CCK-2617.0-11-25
UK Agriculture Research Facility 1 – BP06 Fitout Group 1
PROJECT # 2617.0
ADDENDUM # 2
01/08/2025

**UK AG Research Building
BID PACKAGE – 06 Fitout
ADDENDUM No. 2
CCK-2617.0-11-25
1/8/2025**

TCCO Addendum #2

UK AG Research Working Schedule
Data Date 03-Jan-25

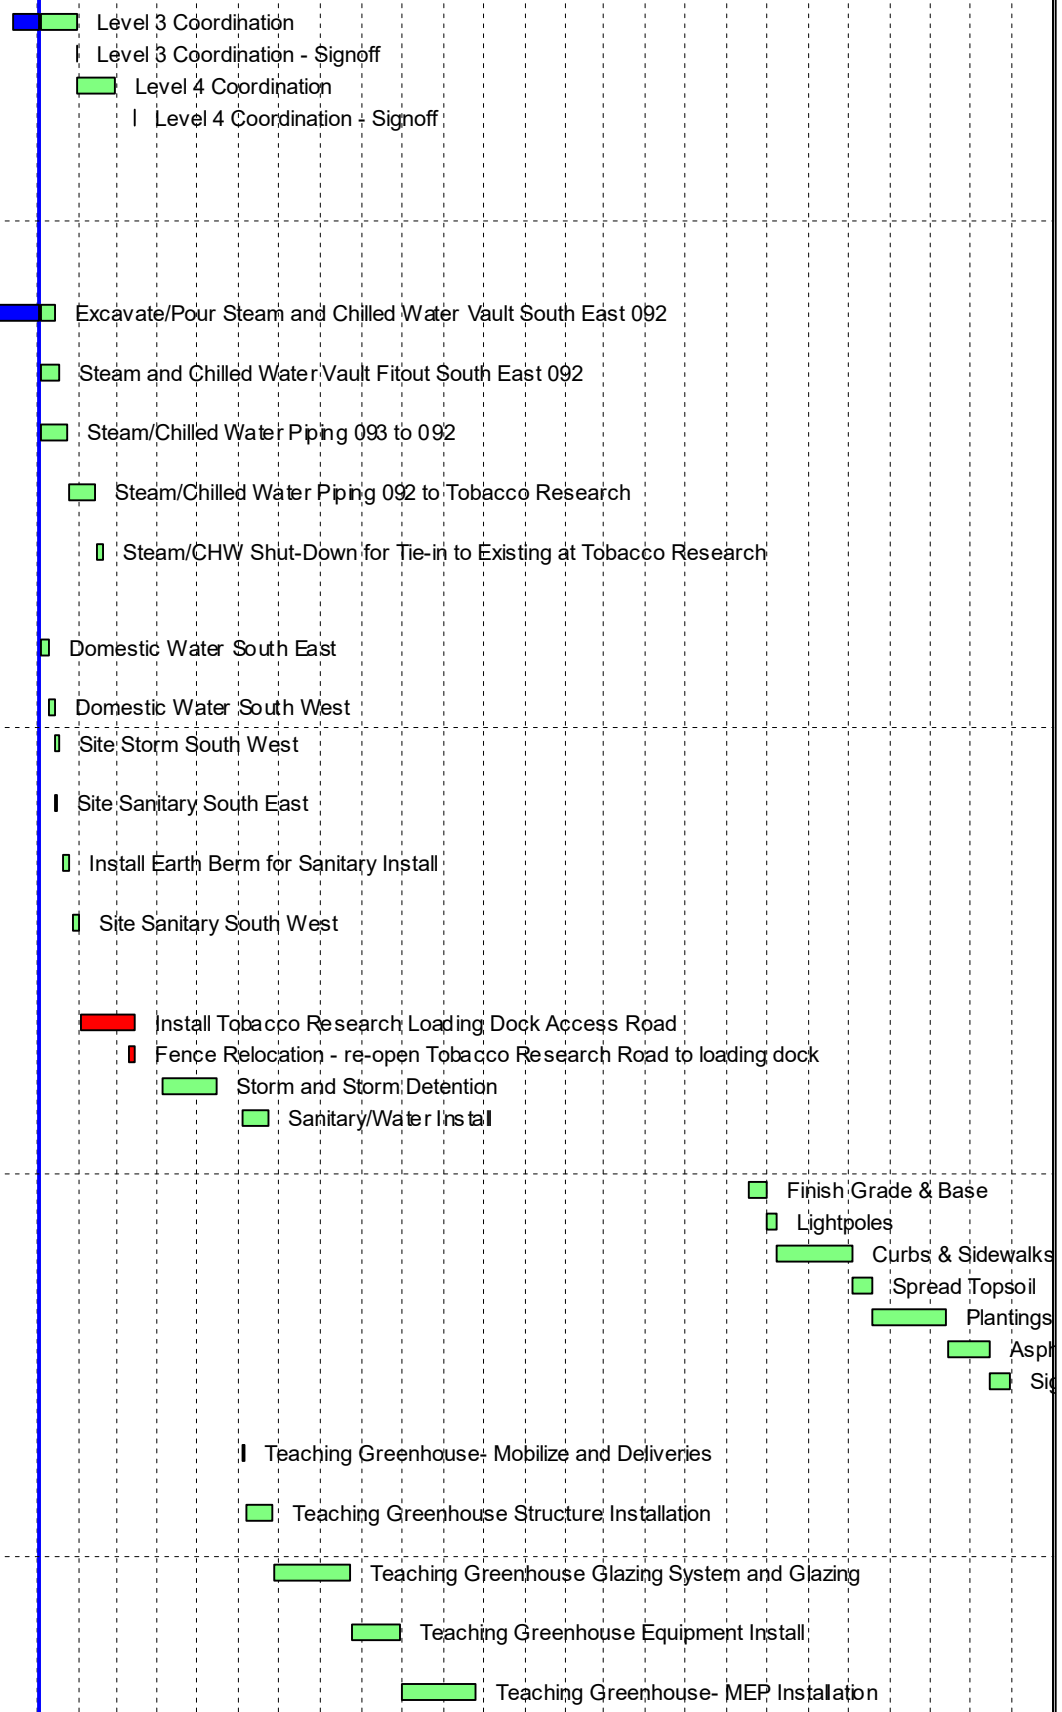
- Replace Attachment G with revised construction schedule data date 1/3/2025
- Geotechnical Report provided for reference
- Substitution Request form provided for material substitution requests
- Pre-bid meeting slide deck included for reference
